## CHANGE REQUEST

⌘ **24.008 CR** ⌘ rev **-** ⌘ Current version: **3.6.0** ⌘

<b>Title:</b>	⌘ Modification to MS's MM states to enable LCS signalling on RR layer		
<b>Source:</b>	⌘ Nokia		
<b>Work item code:</b>	⌘ LCS	<b>Date:</b>	⌘ 07.03.2001
<b>Category:</b>	⌘ <b>A</b>	<b>Release:</b>	⌘ R99
		<p><i>Use <u>one</u> of the following categories:</i></p> <p><b>F</b> (essential correction)  <b>A</b> (corresponds to a correction in an earlier release)  <b>B</b> (Addition of feature),  <b>C</b> (Functional modification of feature)  <b>D</b> (Editorial modification)</p> <p>Detailed explanations of the above categories can be found in 3GPP TR 21.900.</p>	
		<p><i>Use <u>one</u> of the following releases:</i></p> <p><b>2</b> (GSM Phase 2)  <b>R96</b> (Release 1996)  <b>R97</b> (Release 1997)  <b>R98</b> (Release 1998)  <b>R99</b> (Release 1999)  <b>REL-4</b> (Release 4)  <b>REL-5</b> (Release 5)</p>

Figure 4.1a / GSM 04.08: Overview mobility management protocol / MS Side

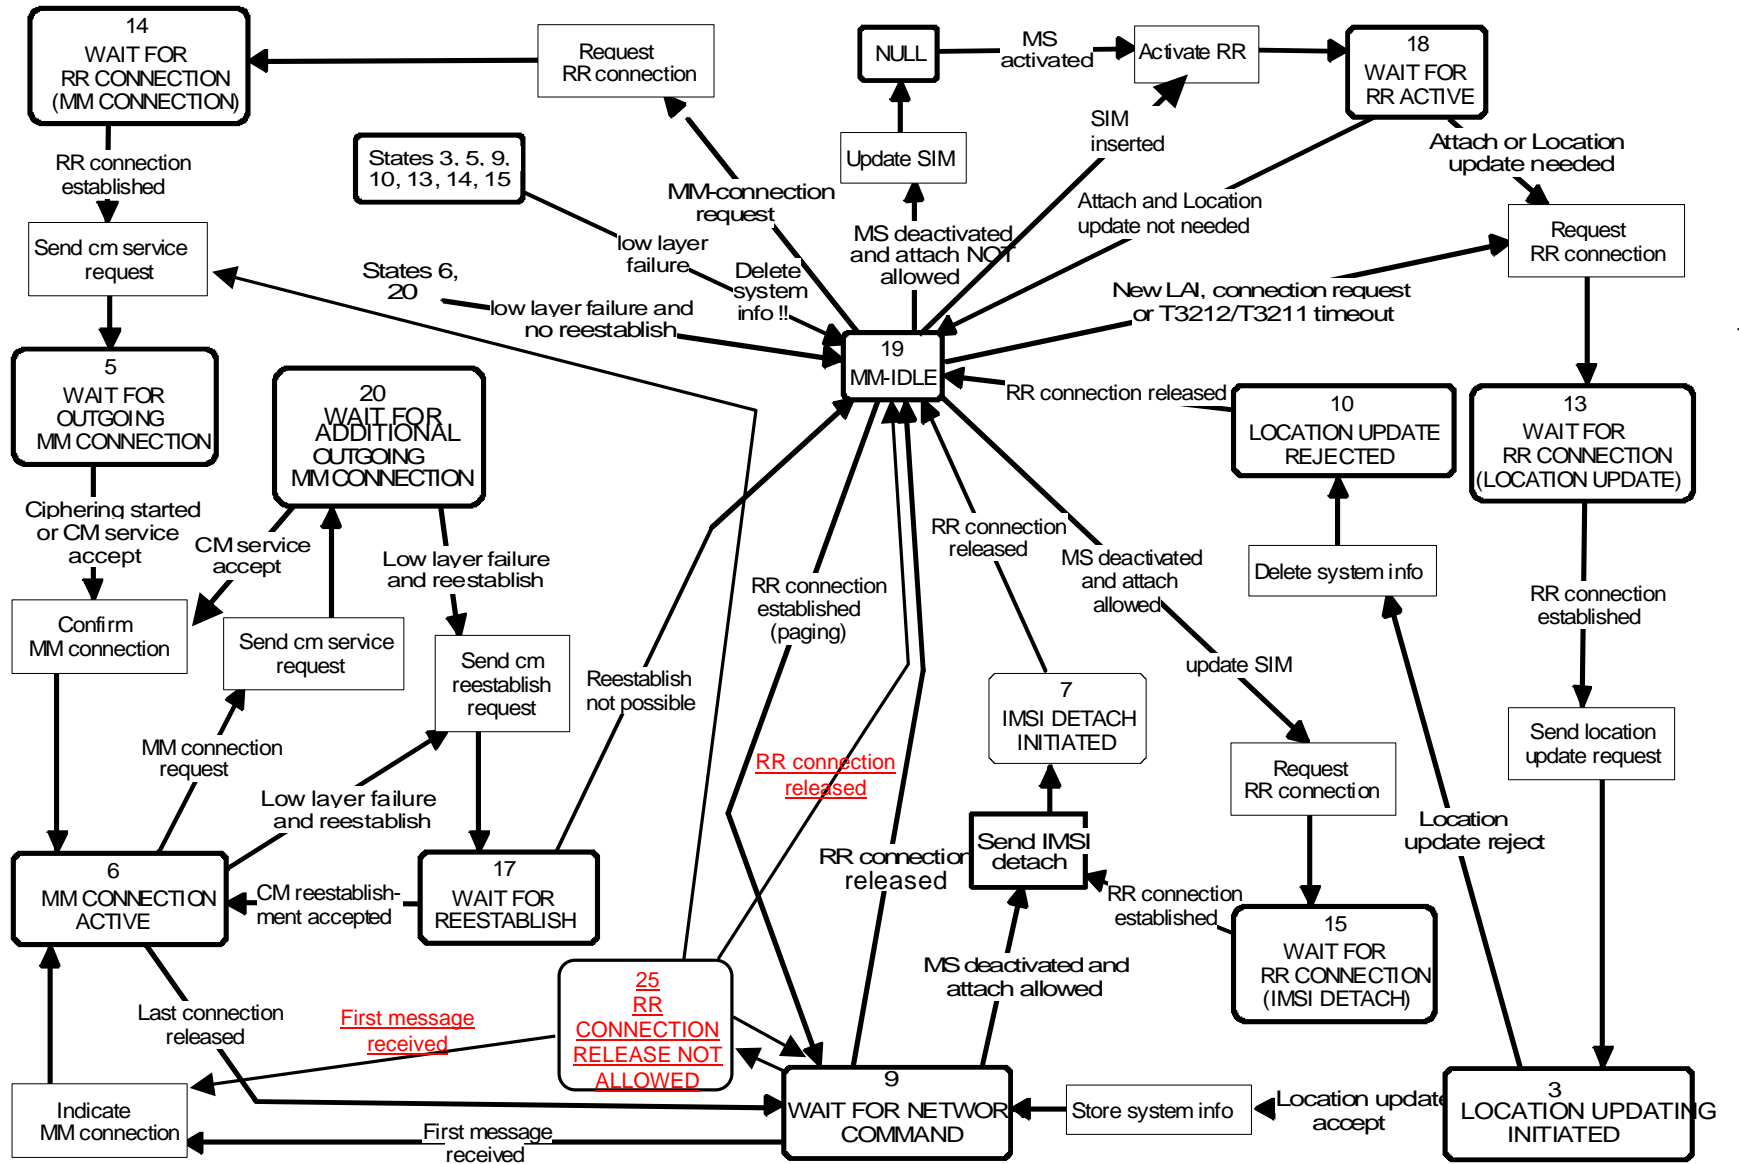
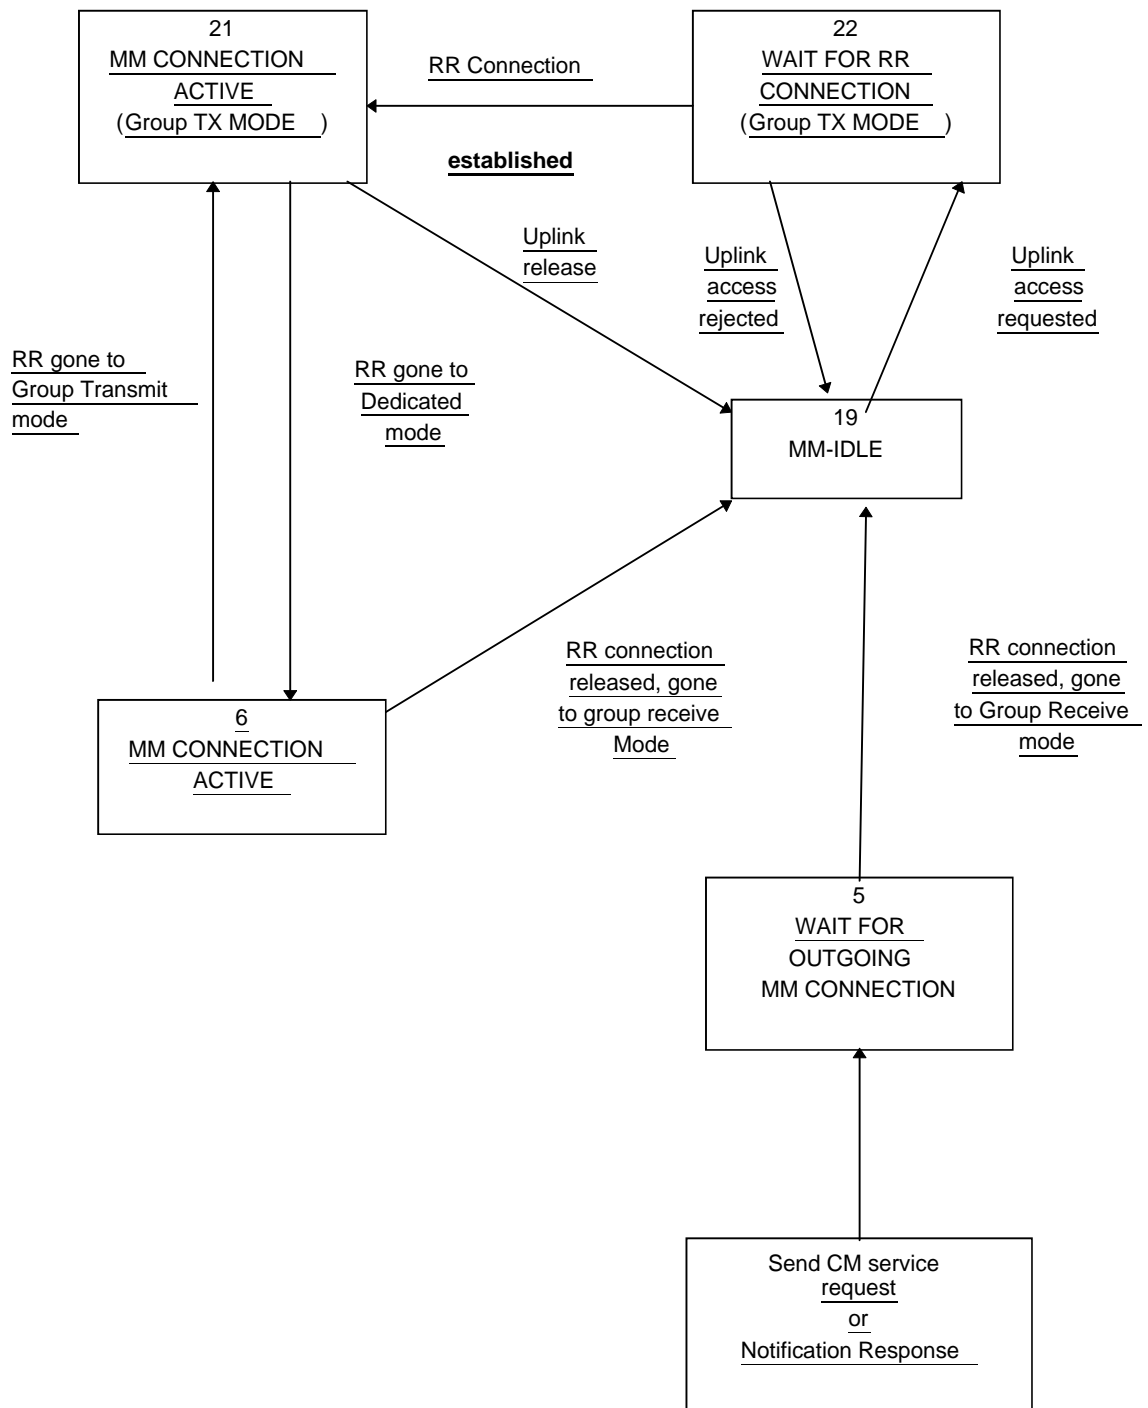
**Additions to Figure 4.1.a/GSM 04.08**

#### 25. RR CONNECTION RELEASE NOT ALLOWED

(Only applicable for MSs supporting LCS) There is no MM procedure running but RR connection exists. The timer T32xx is running.
